MOORSYDE WIND FARM

Comments on the Noise Section of the Environmental Statement and other Documents

9th January 2007

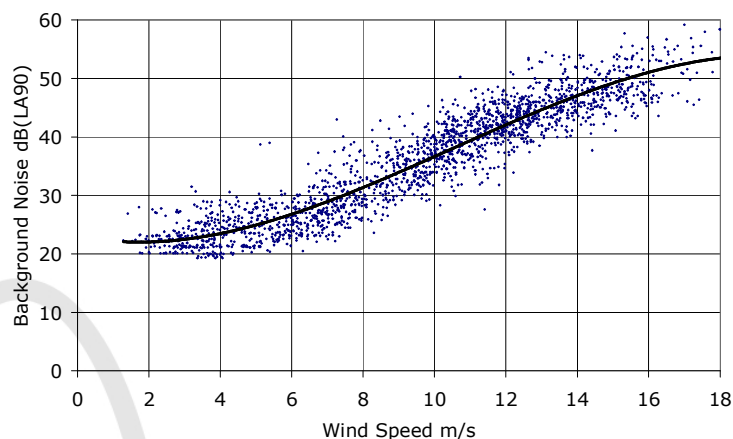
- 4.4 The polynomials used are second order. This means they only curve one way. That is to say they continue to rise more and more steeply with increasing wind speed. The curves should be third order (or higher) because there is a flattening off of noise level as shown in the example below. This is exacerbated because of the lack of data at high wind speeds discussed above.
